**Cleco Corporation**  
2030 Donahue Ferry Rd  
P. O. Box 5000  
Pineville, LA 71361-5000

Re: Public comments of Cleco Corporation on Emission Guidelines for Existing Stationary Sources: Electric Utility Generating Units; Proposed Rule, Docket ID No. EPA-HQ-OAR-2013-0602.

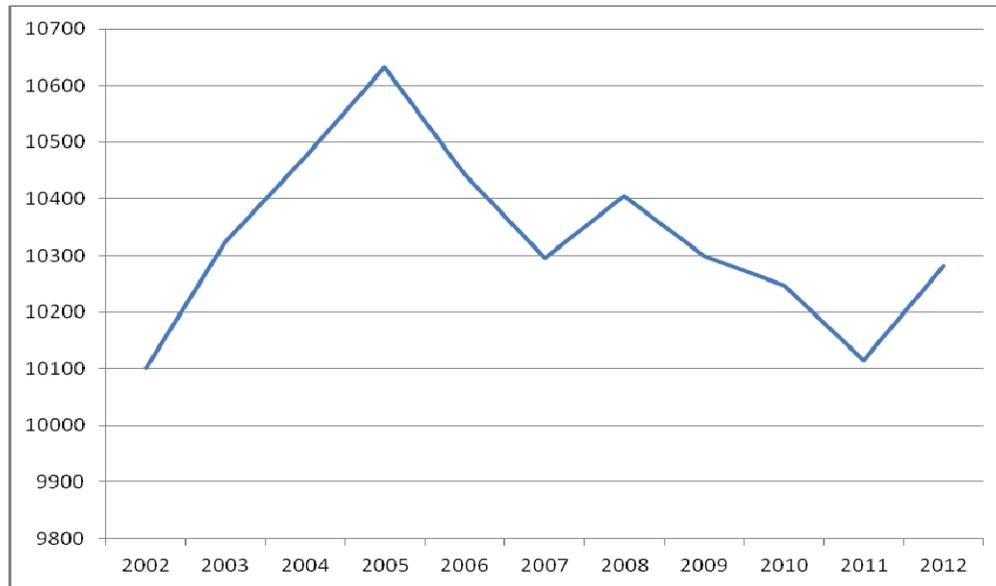
Document ID EPA-HQ-OAR-2013-0602-0236 indicates that a Cleco unit, Brame Energy Center Unit 2, is one of the 16 units EPA lists in support of its analysis. However, Cleco has calculated the annual heat rate for Brame Energy Center Unit 2 over the years 2002-2012 using measured fuel input and measured generated electricity (gross). The heat rate values per year are shown in the table and graph below:

None of the changes in heat rate from one year to the next involve a change of two percent. In fact, these data contradict EPA’s analysis entirely—whereas EPA’s calculations suggest that the heat rate of the unit dropped well below 10,000 Btu/kWh, Cleco’s fuel flow records confirm that the unit has not operated below that level, at least in the past decade. Regardless, Cleco is not aware of any upgrades taking place during the time period that would account for any heat rate improvements referred to in the TSD GHG Abatement Measures.
